<b>CITY OF WESTMINSTER</b>			
<b>PLANNING APPLICATIONS SUB COMMITTEE</b>	<b>Date</b>	<b>Classification</b> For General Release	
<b>Report of</b> Director of Place Shaping and Town Planning		<b>Ward(s) involved</b> Knightsbridge And Belgravia	
<b>Subject of Report</b>	<b>13 - 17 Montpelier Street, London, SW7 1HQ</b>		
<b>Proposal</b>	<p>Applications 1 and 2: Details of all new windows showing traditional joinery details and new internal doors, which on the first and second floors should be traditional panelled doors pursuant to condition 7 of listed building consents dated 20 July 2021 (RN: 21/01234/LBC and RN: 20/07401/LBC).</p> <p>Application 3: Detailed drawings of the new shopfronts pursuant to condition 9 of listed building consent dated 20 July 2021 (RN:20/07401).</p> <p>Applications 4 and 5: Detailed method statement for the removal of the paint on the external facade and sample area demonstrating the intended method of removal pursuant to condition 8 of listed building consents dated 20 July 2021 (RN:21/01234/LBC and RN:20/07401/LBC).</p>

<b>Agent</b>	Mrs Charlotte Jordan		
<b>On behalf of</b>	Monte London Ltd		
<b>Registered Number</b>	Application 1: 21/06227/ADLBC Applic

Consented Front Elevation

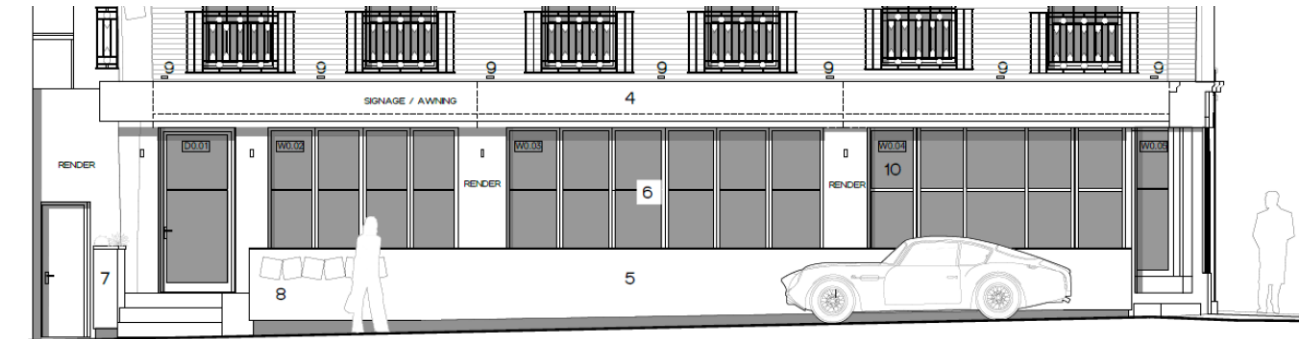
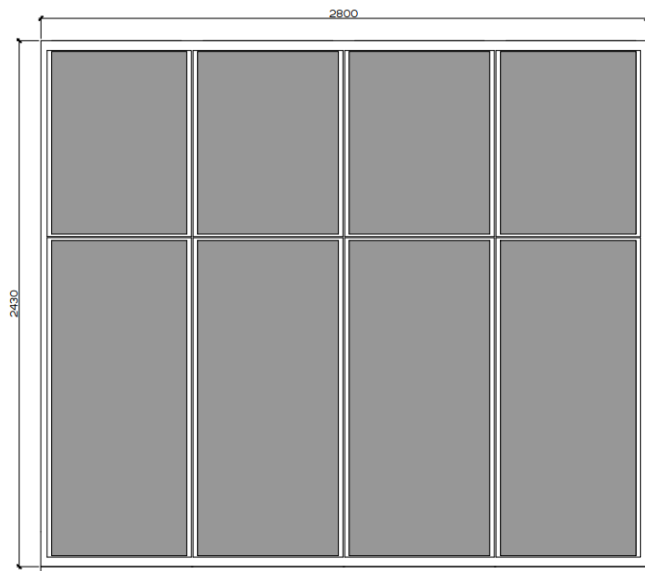
The approved scheme included the removal and replacement of the modern shopfront to nos. 13 and 15 Montpelier Street. The existing shopfronts to nos. 13 and 15 feature a run of single paned casement units, with a narrow fan-light above. These are modern additions to the building which do not contribute to the significance of the grade II listed terrace. The traditional design of the replacement shopfronts closely replicates the glazing pattern of the multi-paned shopfront to no. 17, which is of historic value, and is being retained.

Following officer advice, the joinery details of the new shopfronts were amended to appear more in keeping with the retained shopfront at no. 17, including integral glazing bars and moulded profiles.

Applications 4 and 5 : The proposal seeks to turn 3 individual houses into one uniform block. The deco style railings to number 15 should be retained. No. 13 should retain its white façade. The three houses have augmented their historical individual character over two centuries and should not be homogenised into one block.

The details are considered to accord with the listed building consents and provide satisfactory and acceptable details which would preserve the appearance of the buildings. An informative is attached to the decision notice advising that the replacement shopfronts will require planning permission.

Listed building consent has been granted for the removal of the paintwork to no. 13 to restore the appearance of the terrace, which was intended as a set piece. The method of removal proposed is considered appropriate.

**Typical Proposed Window Details:**

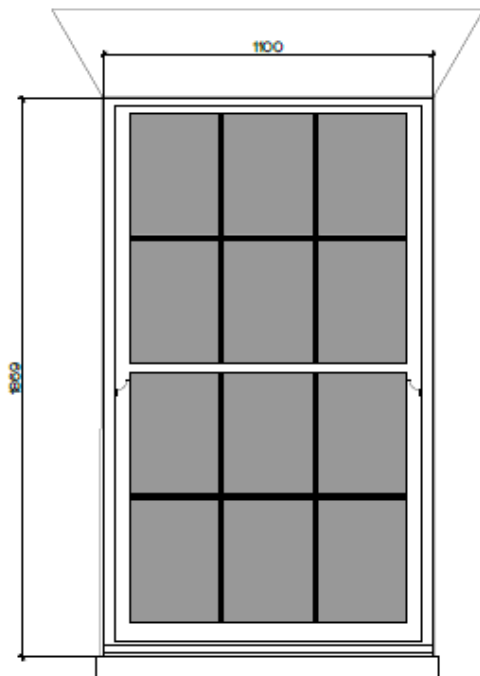
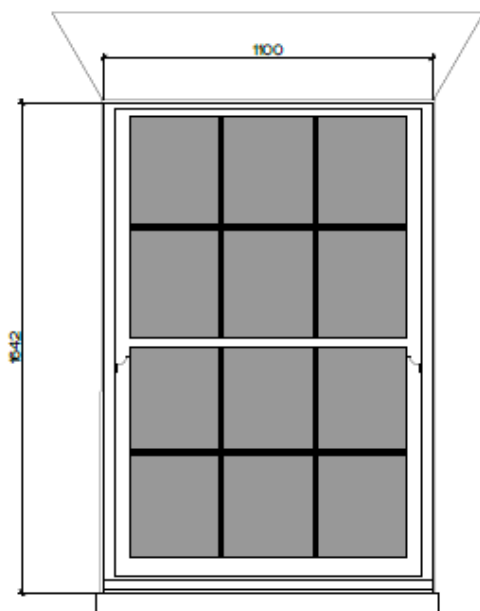
The proposed window details are for traditional timber sliding sashes with slim double-glazed units. The proportions, glazing pattern and joinery profiles closely match the existing windows, and will appear as suitable additions to the building, preserving the buildings appearance and significance.

The details are considered to accord with the listed building consents and provide satisfactory and acceptable details which would preserve the appearance of the buildings.

### Typical Internal Doors Details:

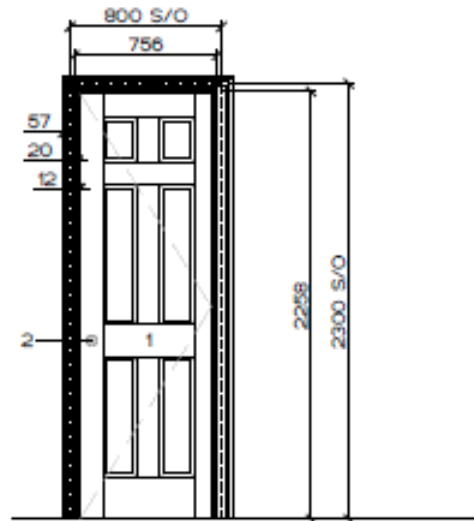
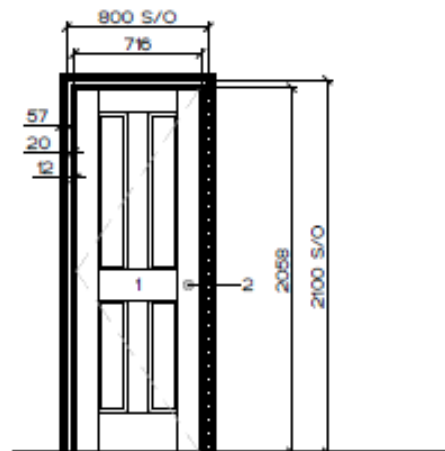
The internal doors intended for the basement and ground floor levels are entirely modern in their design, which given the altered nature of these areas, is considered appropriate. More traditional style, four panelled doors are proposed for the upper floors in order to maintain some of the internal character of the building.

Application 1 and 2: A number of the doors are external and do not fall within the remit of the condition. The external doors require planning permission.
